From: Detterman, Mark, Env. Health
Sent: Wednesday, July 02, 2014 8:51 AM
To: 'Yola Bayram'
Cc: Steve Michelson
Subject: RE: RO#151 1700 Jefferson Oakland, CA

Subject: RO#151 1700 Jefferson Oakland, CA

Figure - 4a
Proposed Sampling Locations
Detail Map
1700 Jefferson Street, Oakland, CA

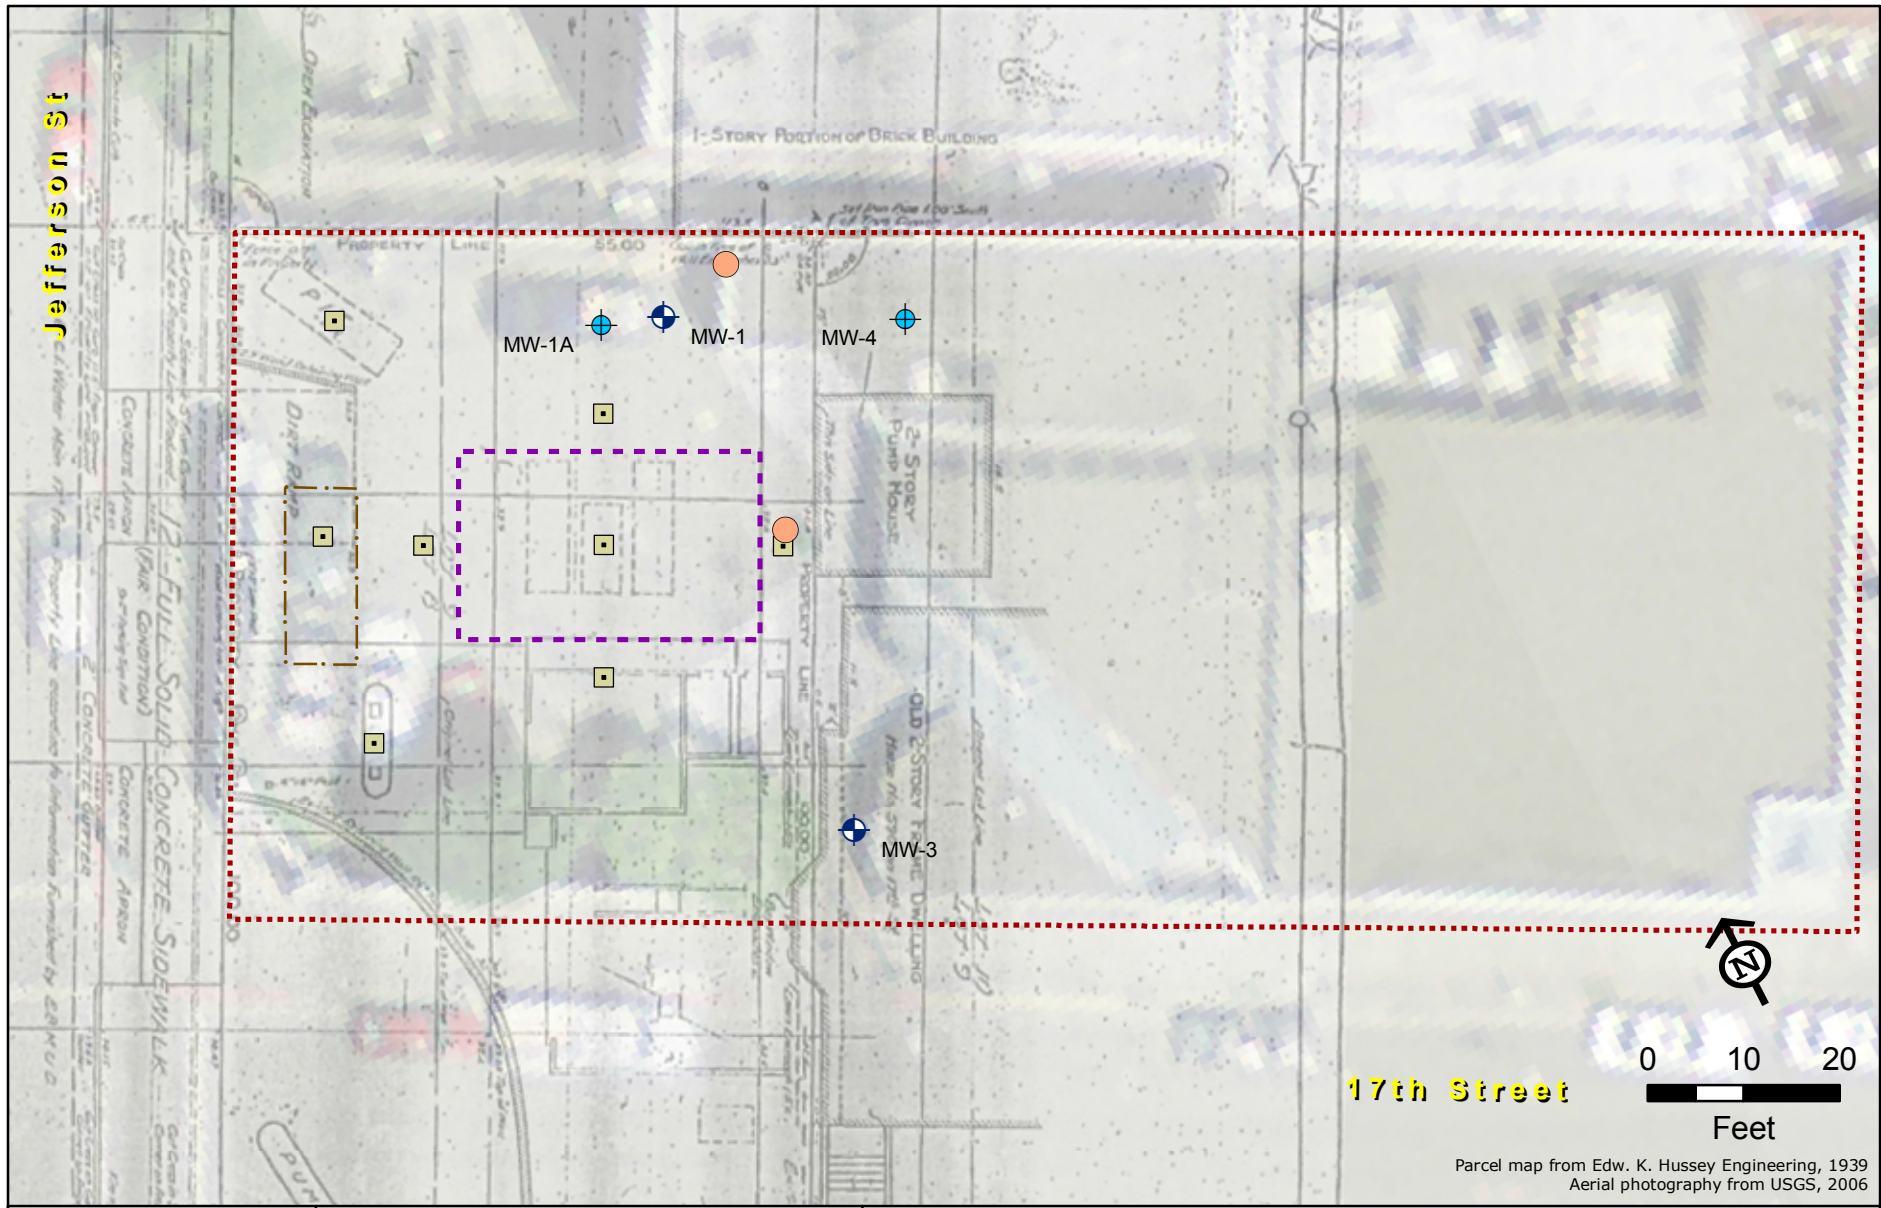
Thanks for the updated site figure. The proposed additional bore is noted. I'm not sure however if it is placed at the same location as the "pit" as the "pit" appears to be pretty close to the northern corner of the lot. I do note that property lines have shifted at the site over time. I ask only that an effort to co-locate the two is made.

An additional soil boring will be advanced in the area of the pit in the northwestern portion of the property. The revised Figure 4 is attached.

Yola,
Thanks; that definitely clarifies the locations. The extra bore appears warranted and should gather enough data quickly to determine how to proceed at the site.

I've attached a more detailed figure of the area overlaid with the 1939 plan. In addition to the pit sample, we've also added an additional boring in what we suspect is a possible dispenser island location on the 1939 plan.
